Square Vis Architects Inc.
www.sqvis.ca

Addendum ADD#2

Date: June 1, 2026
Project Name: Verona Housing
Project Address: 6094 Carleton Dr, Verona, ON K0H 0B8
Project Number: 26001

1 SITE PLAN
Scale 1 : 300

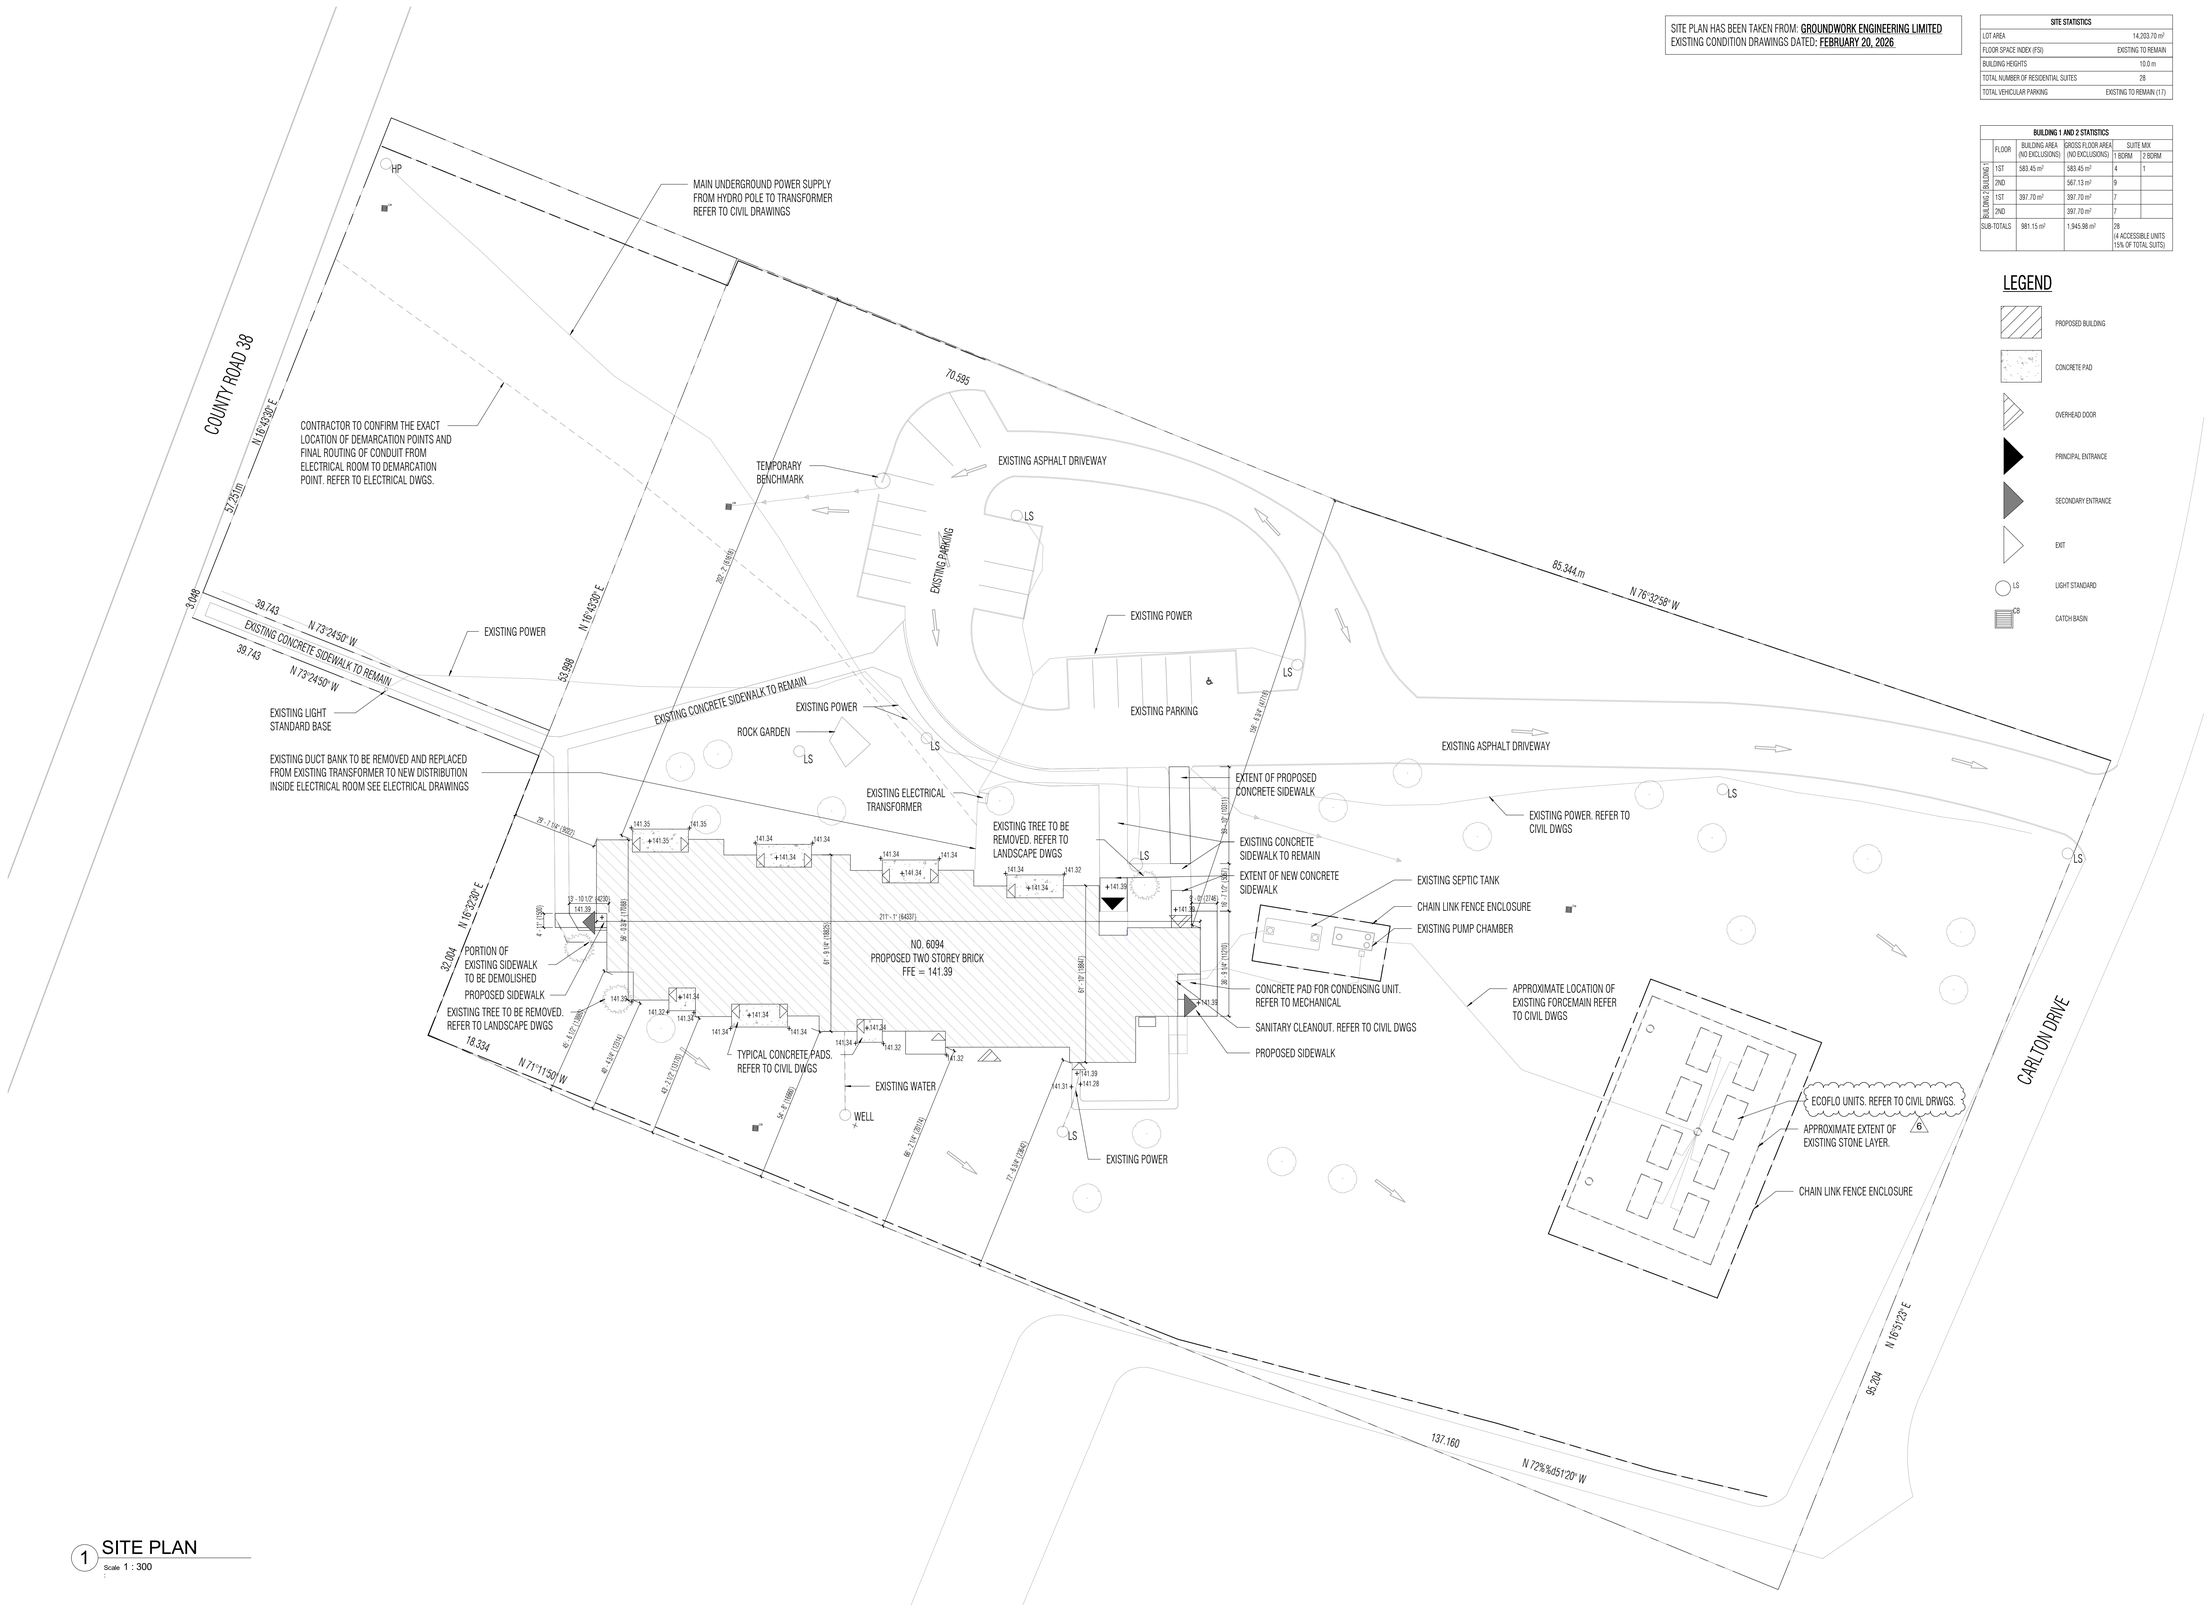
- o. A100: ECOFLO Units labelled.
   - p. A200: Note added to install 4” PVC pipe through the foundation wall as indicated within the granular layer below the slab as part of the Radon Mitigation Measures.

SHEET NUMBER: A201

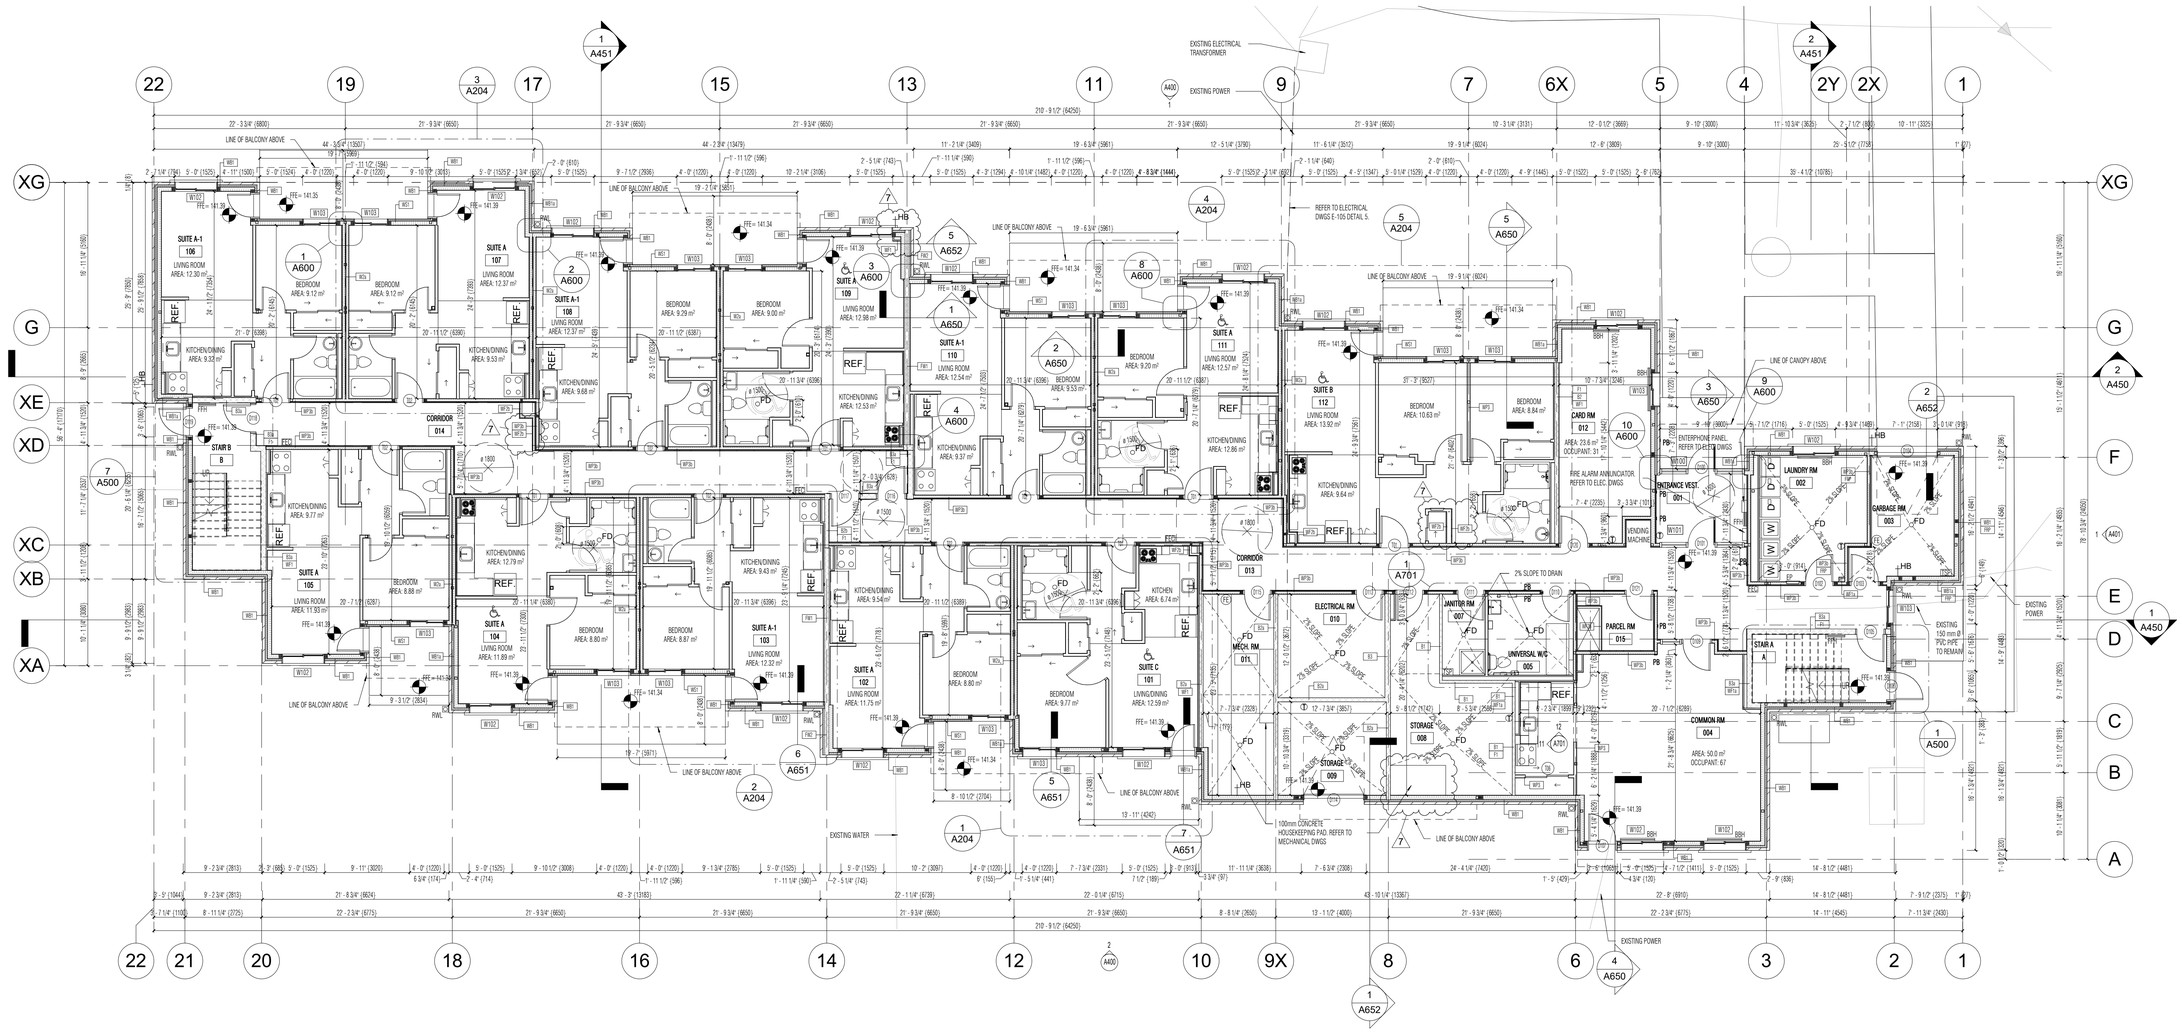
- q. A201: Furring wall added to the corridor wall at Grid 17/XE.

r. A201: Furring wall added to accommodate the hose bib installation at Grid 13/XG.
s. A201: Closet wall type changed in Suite 112.
t. A201: Housekeeping concrete pad added in Storage 008.

SHEET NUMBER: A303

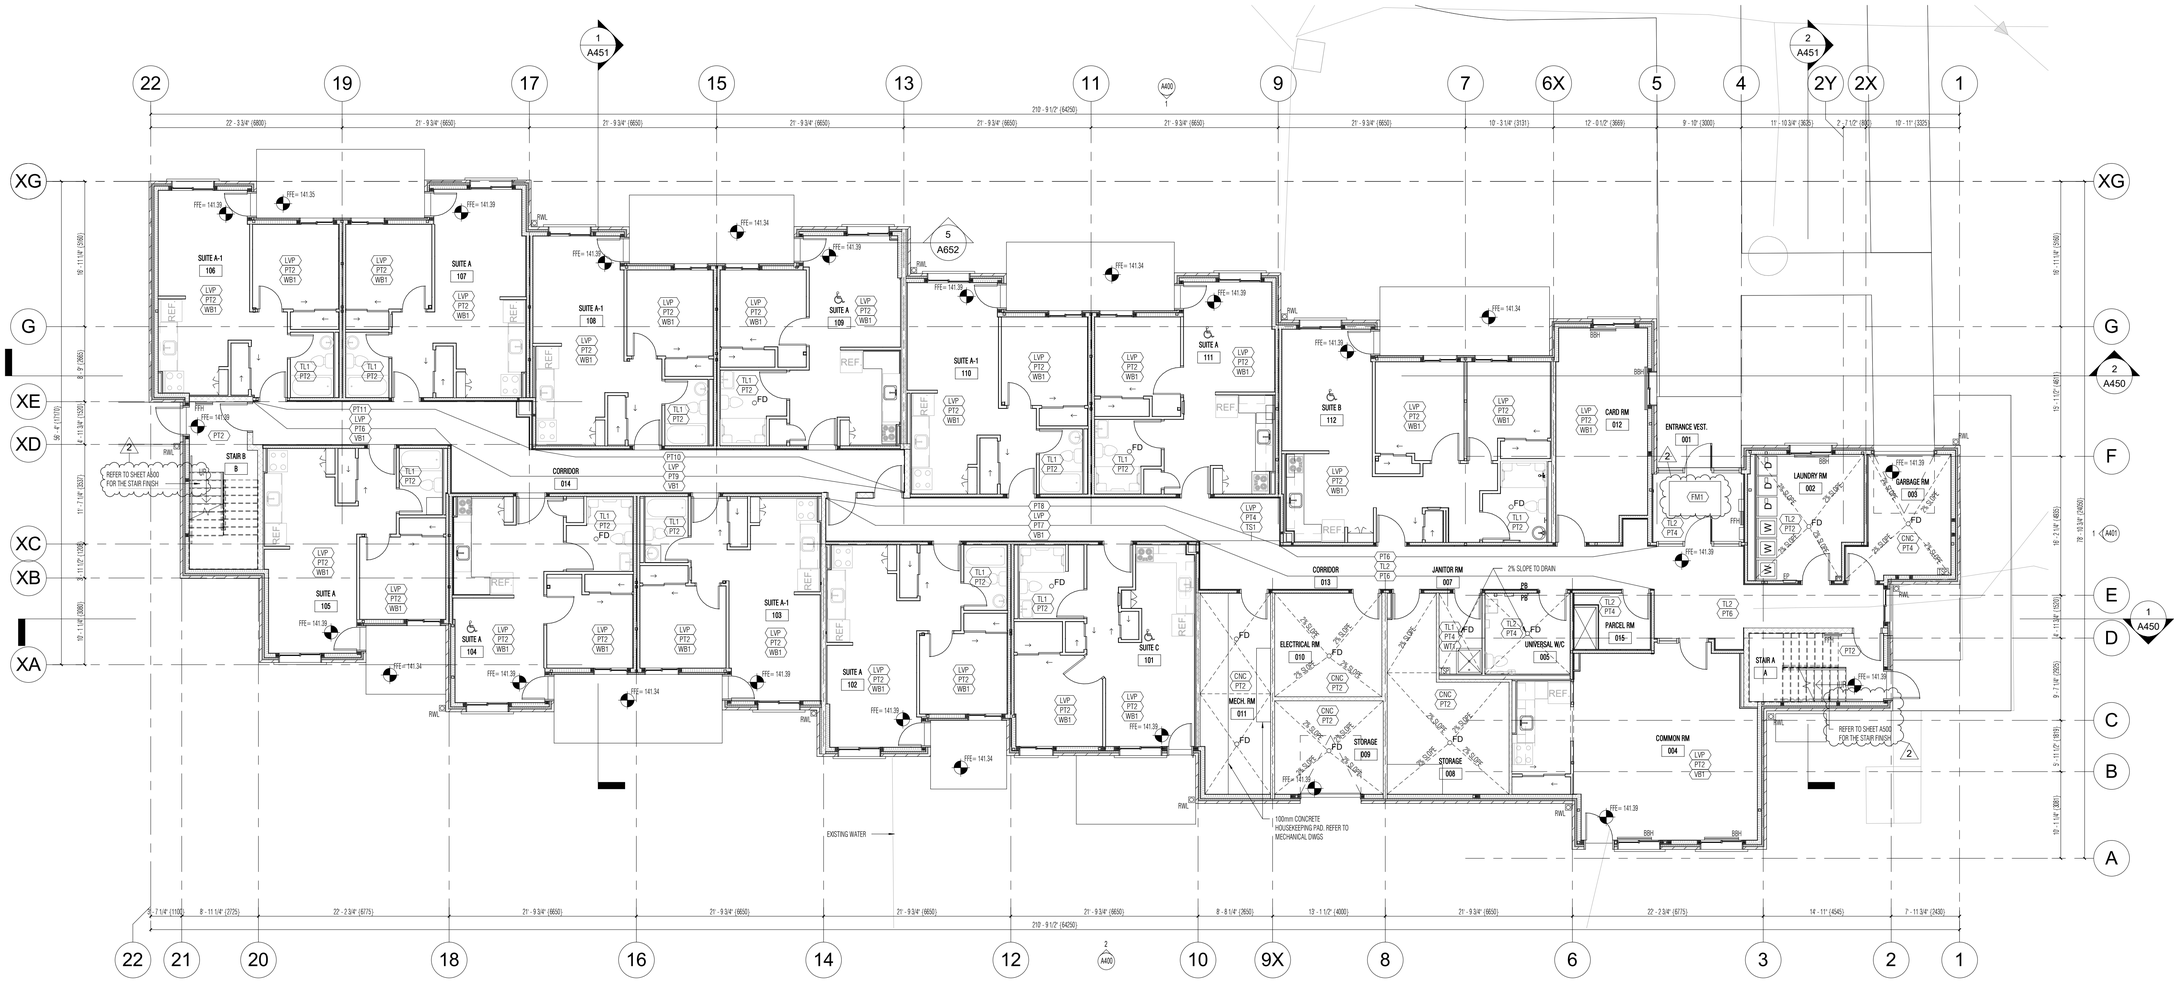
w. A303: Note for stair floor finish added
x. A303: FM1 Floor Mat area shown for reference
y. A304: Note for concrete pad at AHU added in room 517
z. A400, A401: LV1, MT-3, MT-4 and RF1 added to the elevation legend and tags added to the elevation views. Additional RL1 and WD1 tags added to the elevation views.
aa. A451: Detail reference added to the roof overhang, and roof insulation is extended to the wall.
bb. A451: Corridor ceiling is changed to CL6.
cc. A451: Additional notes added for AHU coordination.
dd. A500: Tactile attention indicator note and additional dimensions added to Stair A and B Second floor plan.
ee. A500: Detail 12, Guardrail at Landing added.
ff. A500: Note added for the stringers to be painted and cap ends.
gg. A500: Note added to provide concrete sealer at exposed concrete.
hh. A500: Drywall framing is removed from the steel stair detail 4.
ii. A650: Detail 1: Aluminum siding added to the exposed face of the firewall.

14 SECTION AT RECESSED BALCONY
1 : 10

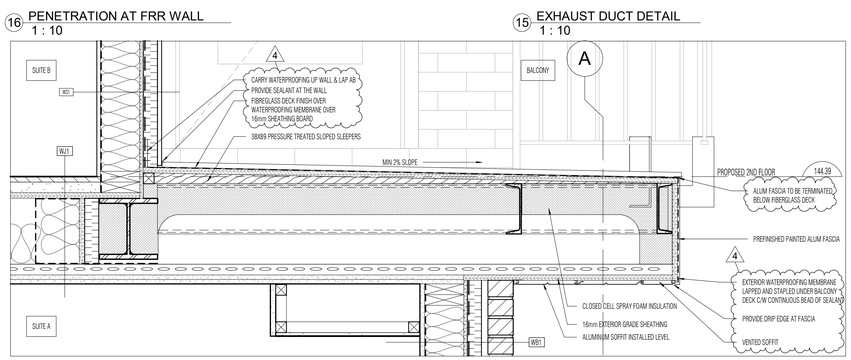
jj. A651: Additional notes added to details 4 and 13.
kk. A651: Exterior Gypsum sheathing size updated in details 5, 6, 9, and 10.
ll. A651: Detail 8: Door sill is updated to an aluminum sill.
mm. A651: Detail14: Decking finish updated and additional note added.
nn. A651: Detail 15: Bulkhead framing is changed to wood framing.
oo. A651: Detail 16: Type 'X' gypsum board encloser added.
pp. A652: Detail 2 updated to match structural drawings.
qq. A652: Detail 6 Privacy Screen Elevation added.
rr. A700: Note added for all exposed pipes to be insulated in Barrier Free suite kitchens and bathrooms.
ss. A700: Details 9 and 10: tub faucet tag is updated to W6.
tt. A700: Shelves added to the suite kitchens.
uu. A701: Change table tag C15 added to detail 1.
vv. A701: Finishes tags added to detail 2-9.
ww. A701: Shelves added to detail 11.
xx. A702: New interior Section Detail sheet added.
